ADDENDUM #4

Will County Health Department
BID PACKAGE #3 – MEP/Finishes/Carpentry/Glazing
December 6, 2018

RFI LOG
Will County Health Department
Bid Package #3 Addendum #4 12/6/18

| SHEET NUMBER | A321 |

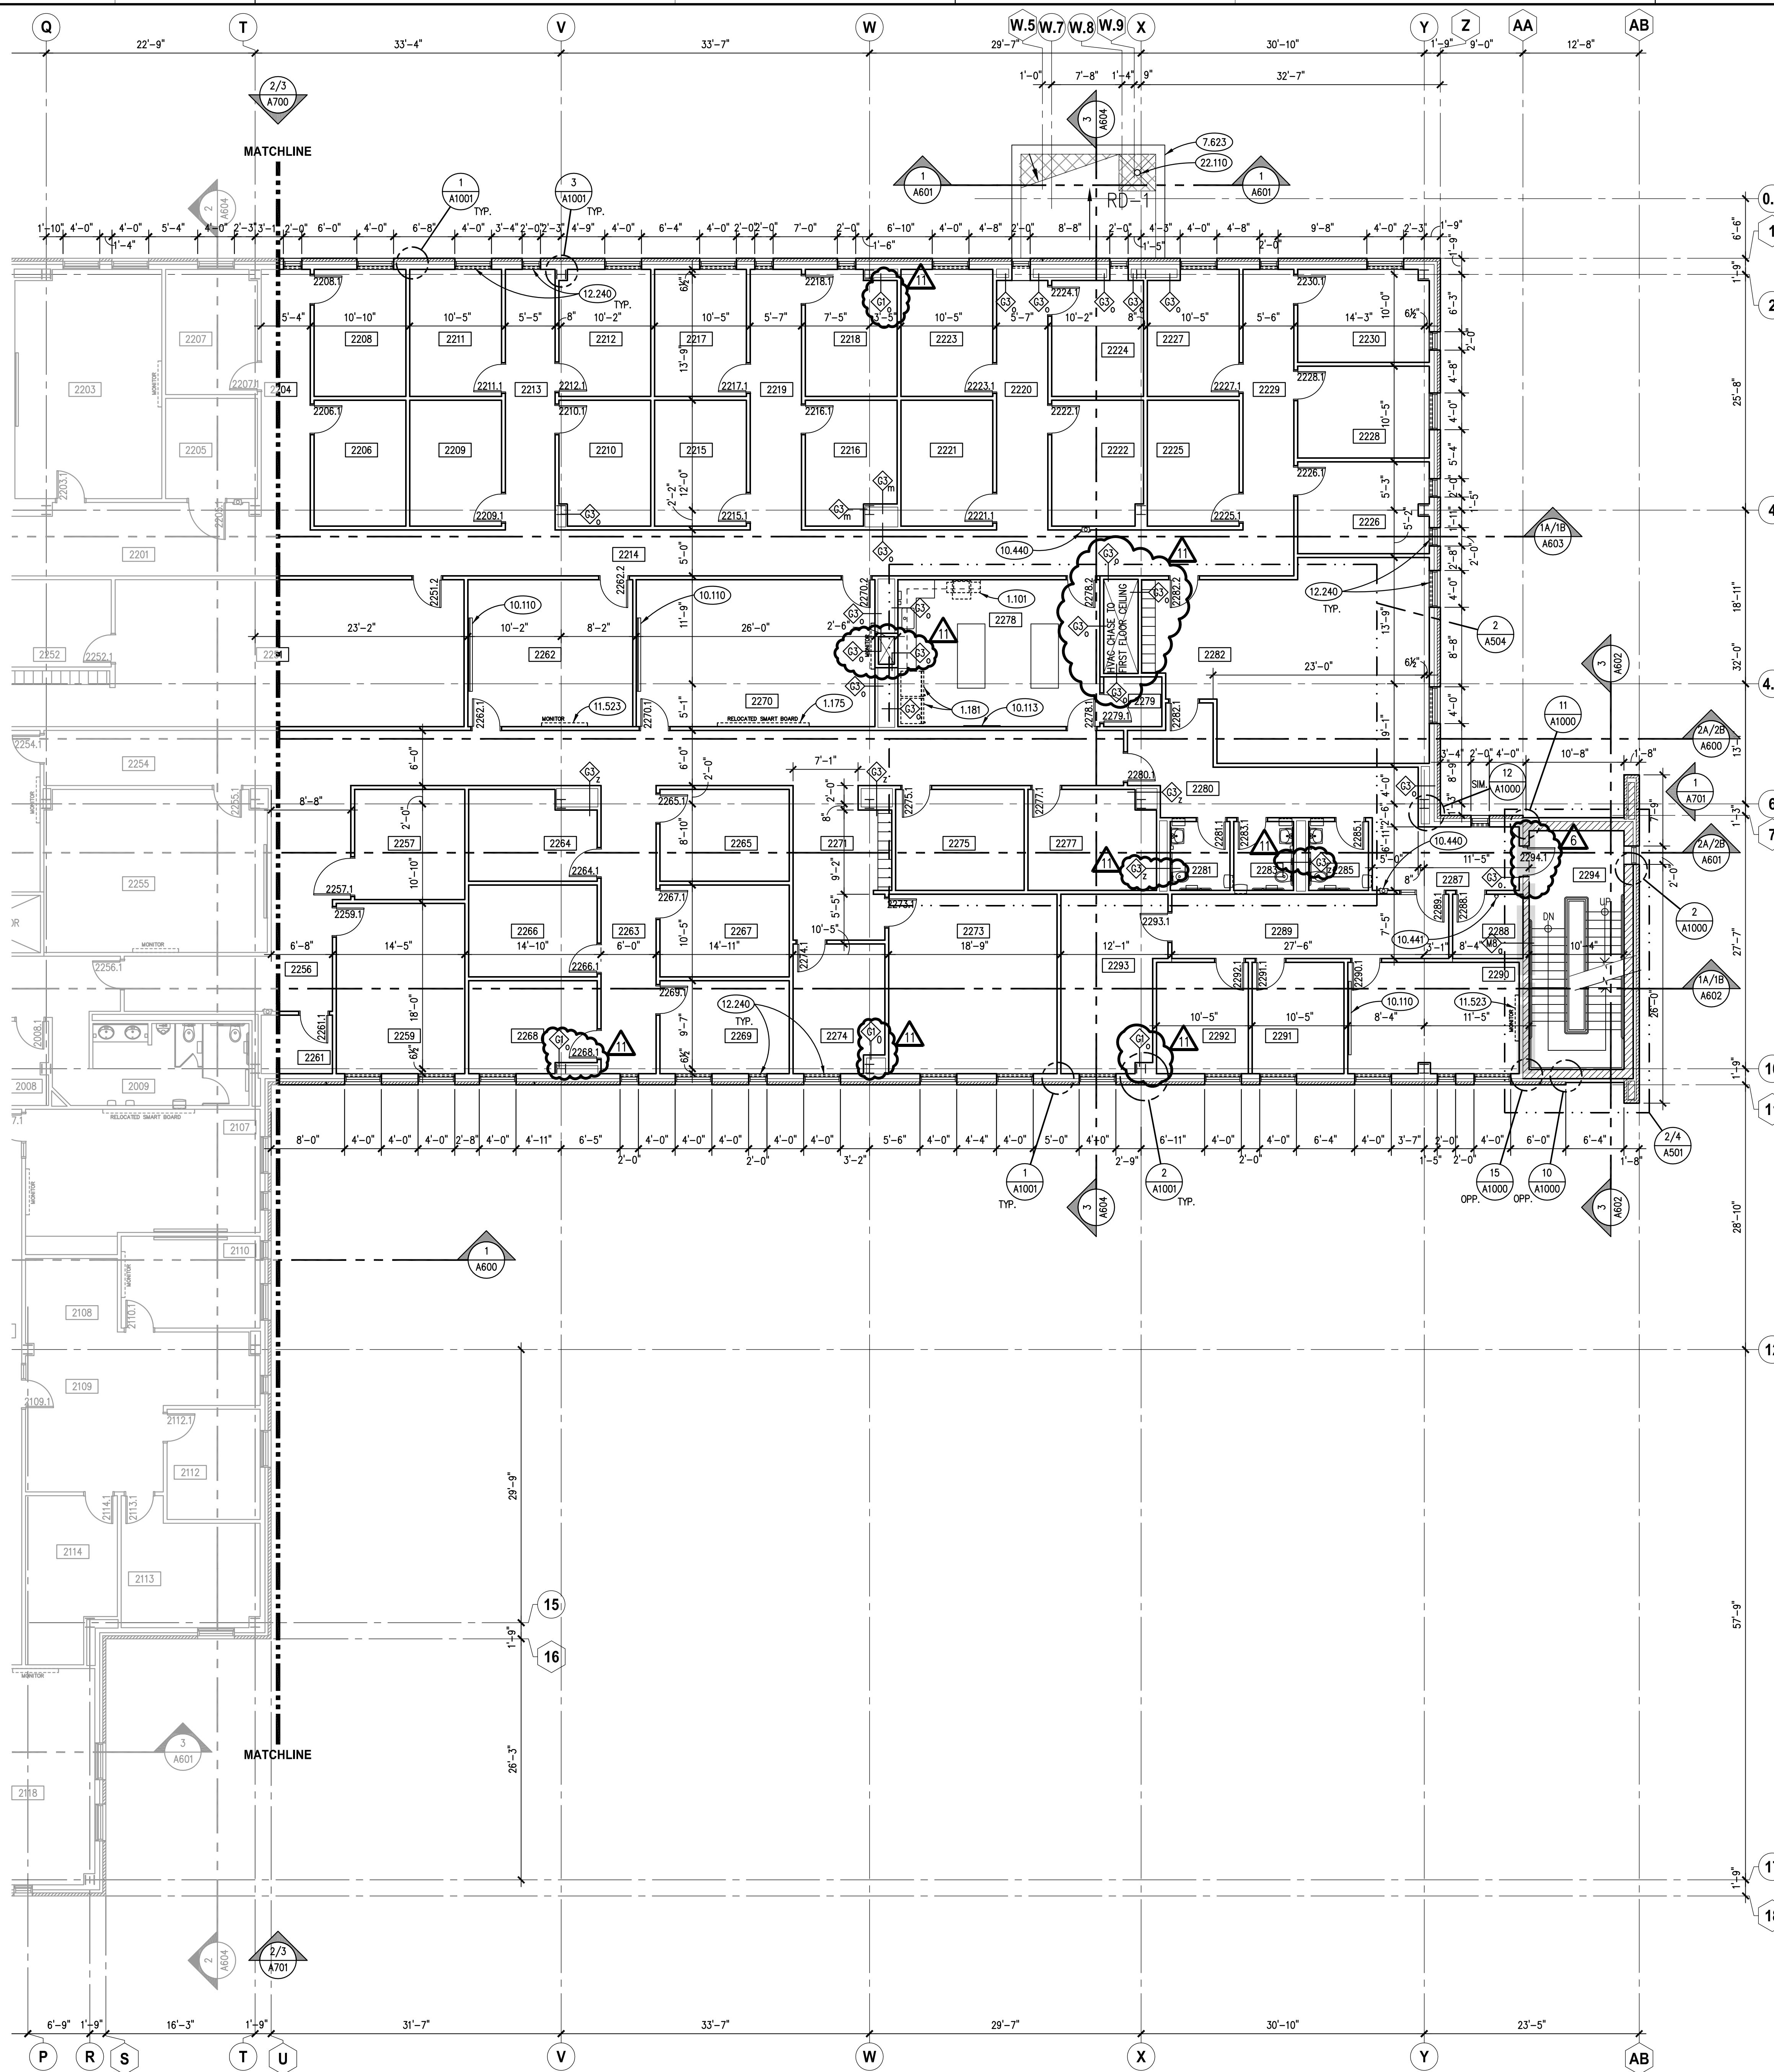
| BP3-056 | Addendum #4 | 2) No wall type listed for G1z. Should we assume same make-up as wall type G3z except with 1-5/8" metal studs? | G1z shall be G1m as shown on sheet A1100. BP#3 - Addendum #4 will clarify and the A321 Sheet near door 2143.1 will have Wall Tag updated. | R |

2.04 DRAWING A321 - PARTIAL SECOND FLOOR PLAN - AREA 'A'

| SHEET NUMBER | A322 |

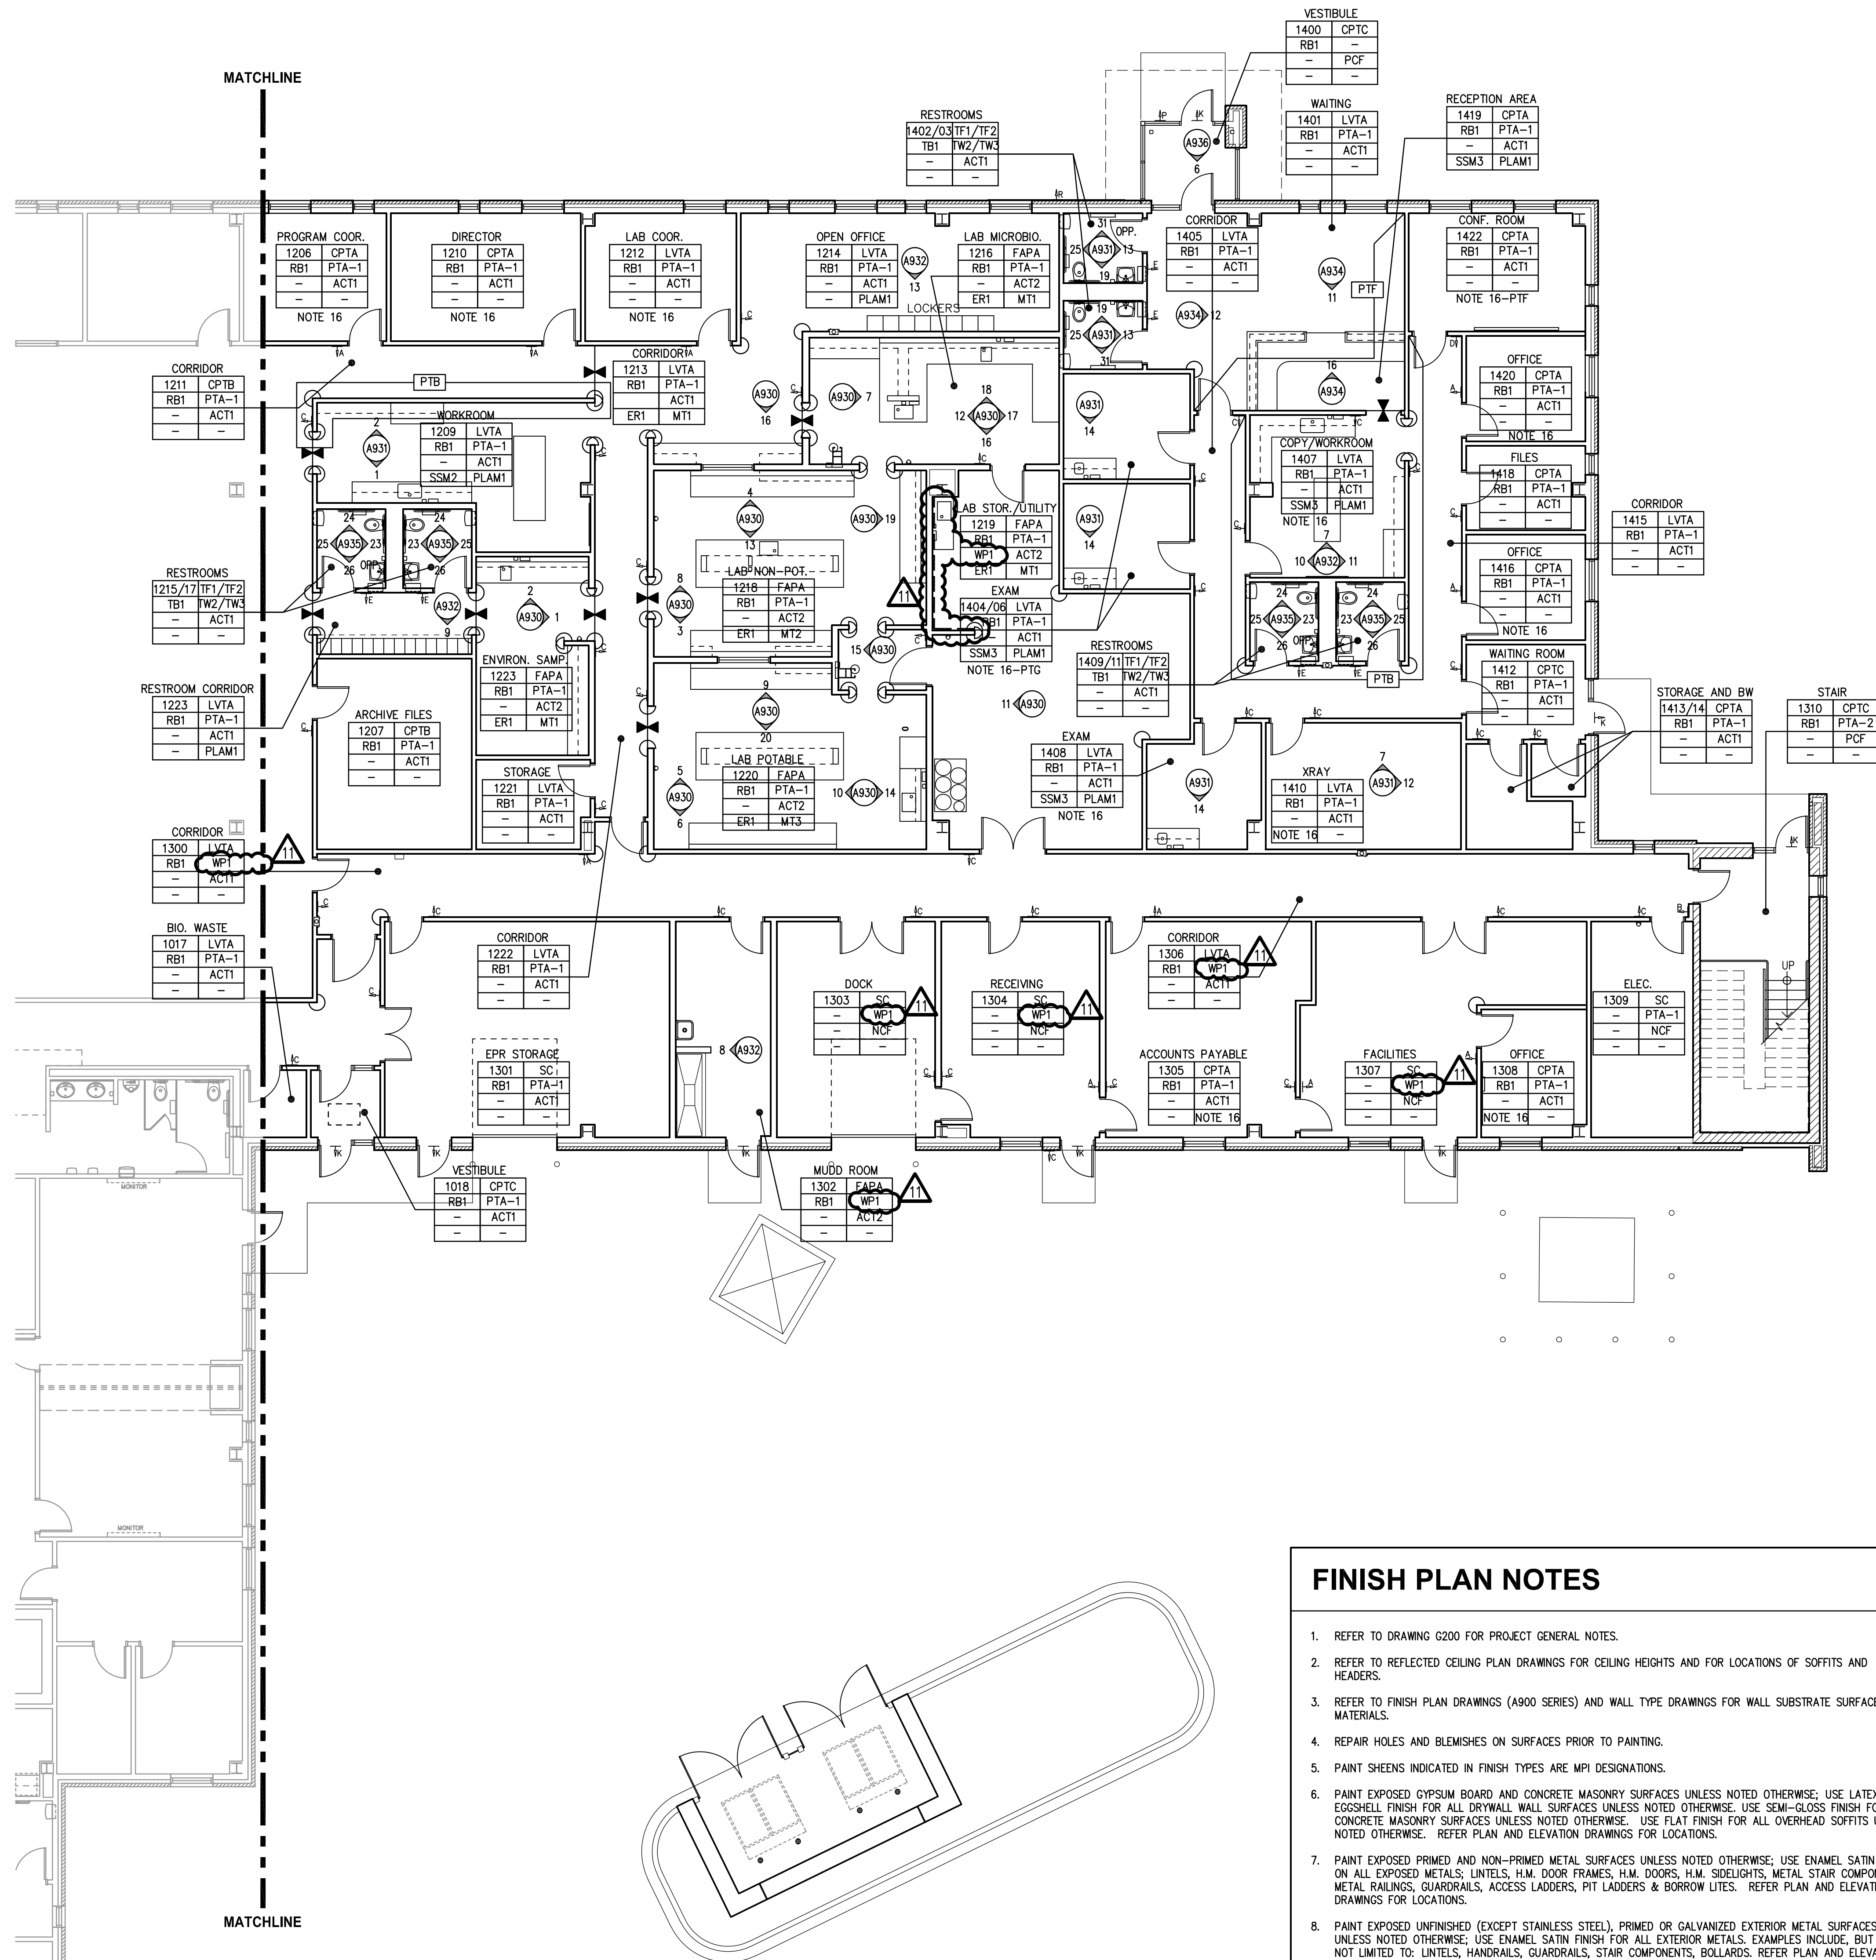
2.05 DRAWING A322 - PARTIAL FIRST FLOOR PLAN - AREA 'B'
